**NOTICE OF APPROVAL
AVIS D'APPROBATION**

G-69-2 and
G-70-1

MODIFICATION TO
ROCKWELL EMCORECTOR TYPES I AND T

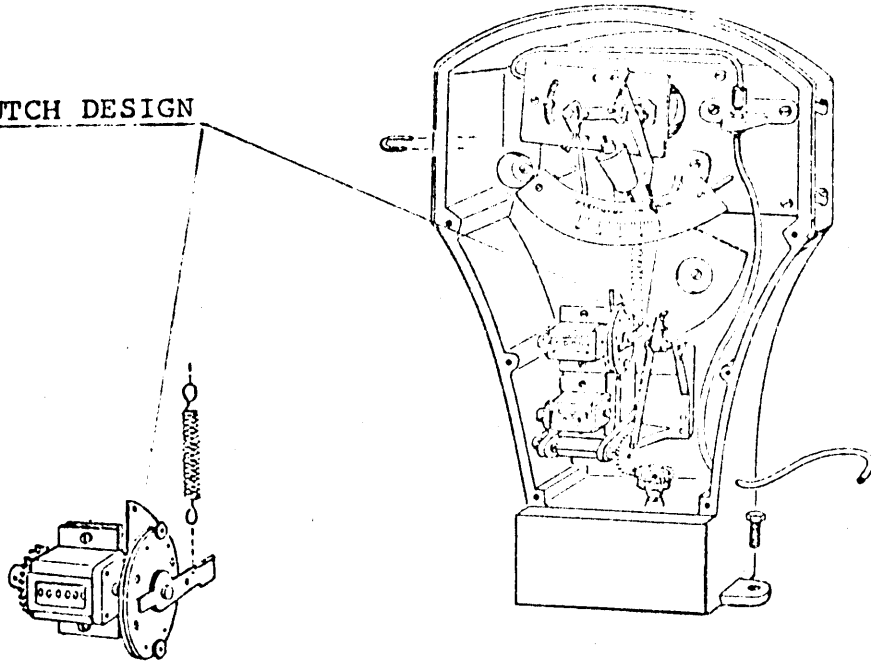
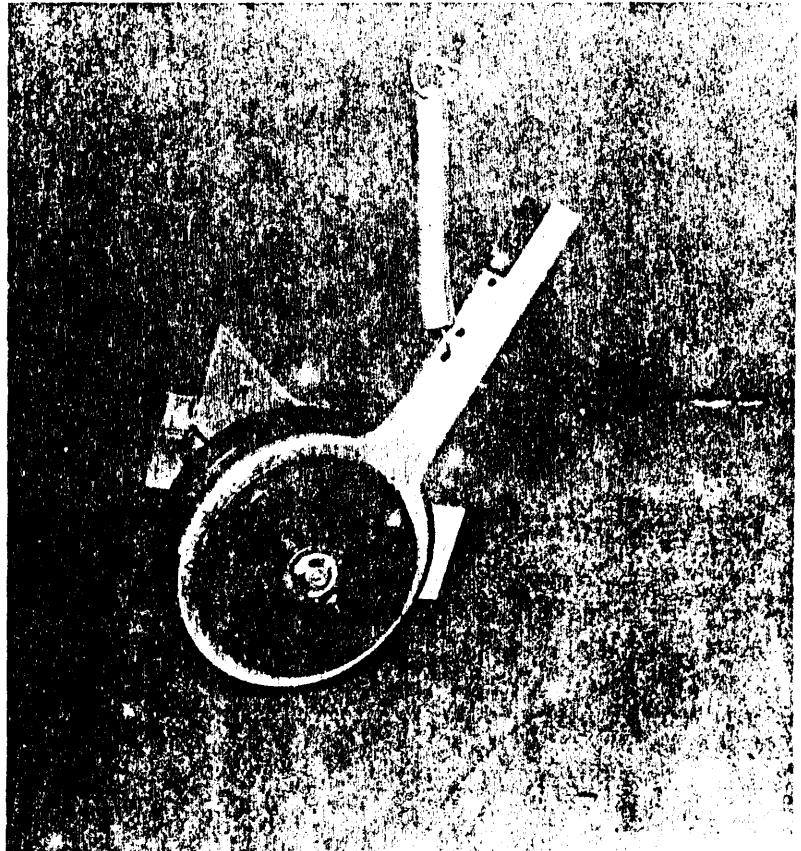
Rockwell Manufacturing Company has introduced a new type of clutch for the above instrument.

The mounting bracket of the new clutch is cast aluminum. The sleeve bearings and the spring have been replaced by roller bearings and ball thrust race. The new clutch is somewhat smaller in size.

Attached illustration shows both versions of the clutch.
